# Access Compliance Report

## Public Rights-of-Way

### (Curb Ramps)

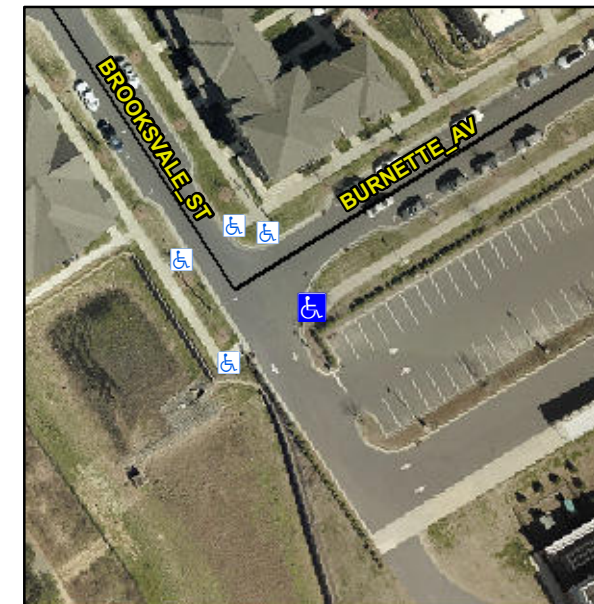
Intersection ID: N/A	Main Street: BROOKSVALE_ST	Cross Street: BURNETTE_AV	Location: SE
ADA ID: 891C973B711A	Ramp Type: PerpDiag	Initial Pass/Fail: Fail	Overall Compliance: No
Severity Score: 46.25			
Codes/Mitigation Info/Possible Solution		Field Measurements/Component Compliance

**Not Found, R304.5.1, R304.2.2, R304.5.3**

Compliance	Description	Data	Compliance	Description	Data
N/A	Ramp Length (in)	74.0	No	Ramp Slope (%)	9.0
No	Ramp Width (in)	47.5	No	Ramp XSlope (%)	8.4
N/A	Flare Type LT	N/A	N/A	Flare Type RT	N/A
N/A	Flare Slope LT (%)	N/A	N/A	Flare Slope RT (%)	N/A
N/A	Flare Traversable LT?	N/A	N/A	Flare Traversable RT?	N/A
N/A	Landing Length (in)	N/A	N/A	DWS Provided?	N/A
N/A	Landing Width (in)	N/A	N/A	DWS Contrast?	N/A
N/A	Landing Slope (%)	N/A	N/A	DWS Length (in)	N/A
N/A	Landing X Slope (%)	N/A	N/A	DWS Full Width?	N/A
N/A	Landing Curb? (Y/N)	N/A	N/A	DWS Offset (in)	N/A
N/A	Shared Landing?	N/A			
N/A	Gutter Ponding?	N/A	N/A	Gutter Slope (%)	N/A
N/A	Gutter Lip Ht (in)	N/A	N/A	Gutter X Slope (%)	N/A
N/A	Painted X Walk1?	No	N/A	Painted X Walk2?	No
	X Walk 1 Direction	To NW		X Walk 2 Direction	To SW
N/A	X Walk 1 Width (in)	N/A	N/A	X Walk 2 Width (in)	N/A
	X Walk 1 Slope (%)	0.7		X Walk 2 Slope (%)	1.5
	X Walk 1 X Slope (%)	4.3		X Walk 2 X Slope (%)	3.2

**Remove & Replace Curb Ramp With Two New Directional Ramps or Equivalent.**
